**RESOLUTION NO. 2019-09  
LOWER PROVIDENCE TOWNSHIP**

**A RESOLUTION OF THE LOWER PROVIDENCE TOWNSHIP  
BOARD OF SUPERVISORS, MONTGOMERY COUNTY,  
PENNSYLVANIA, APPROVING THE PRELIMINARY/FINAL LAND  
DEVELOPMENT PLAN OF EAGLEVILLE HOSPITAL**

Reference: Eagleville Hospital – Campus Revitalization

**SUBJECT:** REVIEW COMMENTS – EAGLEVILLE HOSPITAL  
PRELIM. / FINAL LAND DEVELOPMENT PLAN DATED OCTOBER 31, 2018

= RECOMMENDED ADDITIONAL SHADE TREE

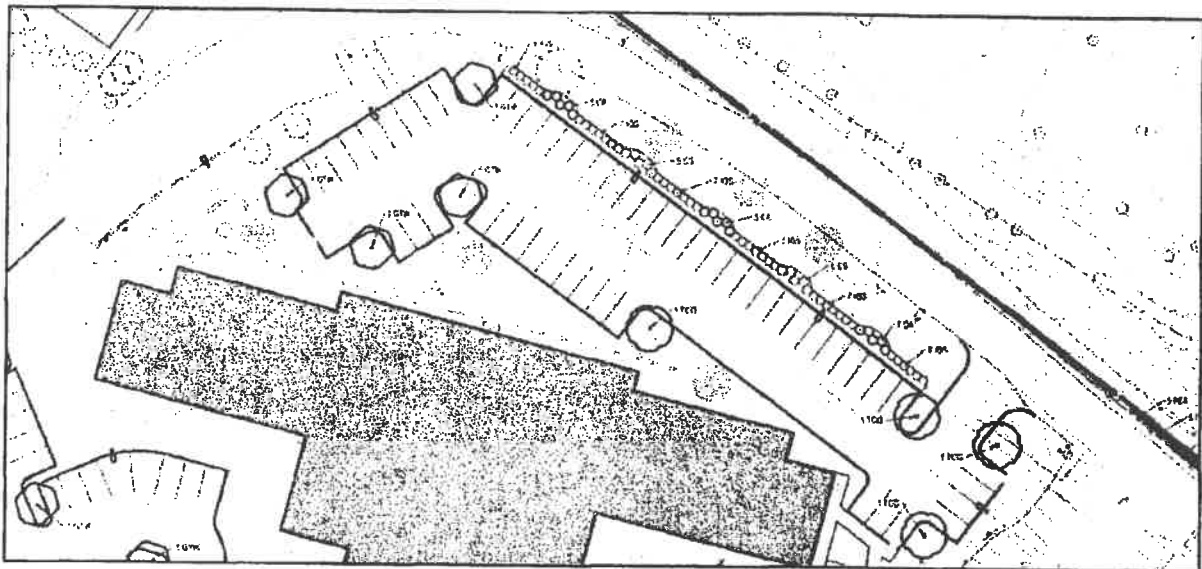
However, there still appears to be additional opportunity to install deciduous trees on the north side of the proposed Hospital Building. Specifically, installing upright-formed deciduous trees in the approximate locations indicated below (the green circles) will help to fulfill the intent of the §143-215 (ZO) Screen Buffer requirements in locations where there is no existing additional buffer planting area, and no vegetation to remain, between the driveway and north property line.

The trees indicated below will also help to fulfill, at least for the north side the Hospital Building, the intent of the Building Foundation Planting requirement, as described further in below comment 5.

(Note: We agree with the Township Engineer that the parking area to the north of the Hospital Building depicted above represents a "dead end" condition that could be eliminated via a connection to the 14-space area to the west. Making such a connection could impact the planting layout.)

= PARKING ROWS WITH GREATER THAN 18 SPACES

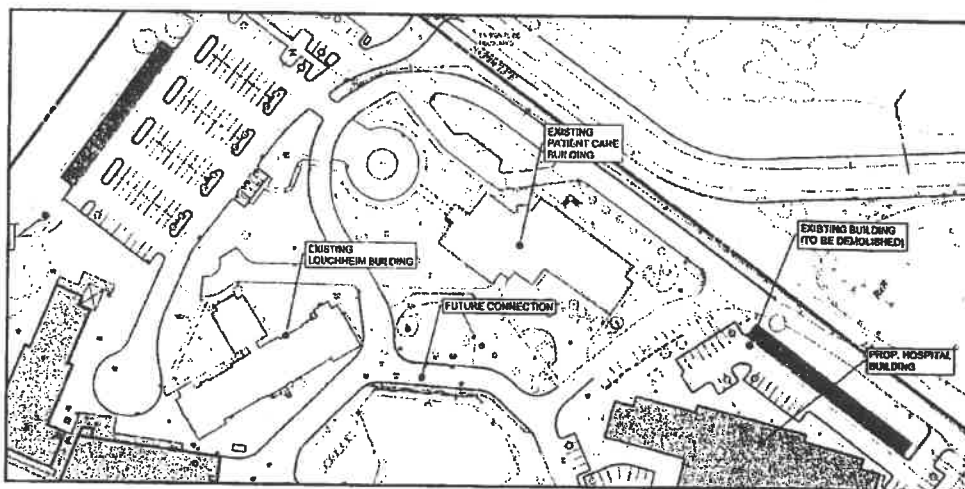
Per §123-37.C (SLDO), no more than (18) parking spaces may be located in an uninterrupted row. If more than (18) parking spaces are located in a row, a raised and curbed planted area with a minimum size of nine (9) feet by (18) feet shall be located at appropriate intervals to provide shading and visual interest. Each planted island shall contain a shade tree of at least two-and-one-half inches (2½") caliper.

The Plan excerpt below indicates the two (2) proposed rows of parking that exceed 18 parking spaces (22 parking spaces in the row at the right of the excerpt, 25 parking spaces at the left):

The Plan should be revised so that there are no rows of parking longer than (18) spaces.
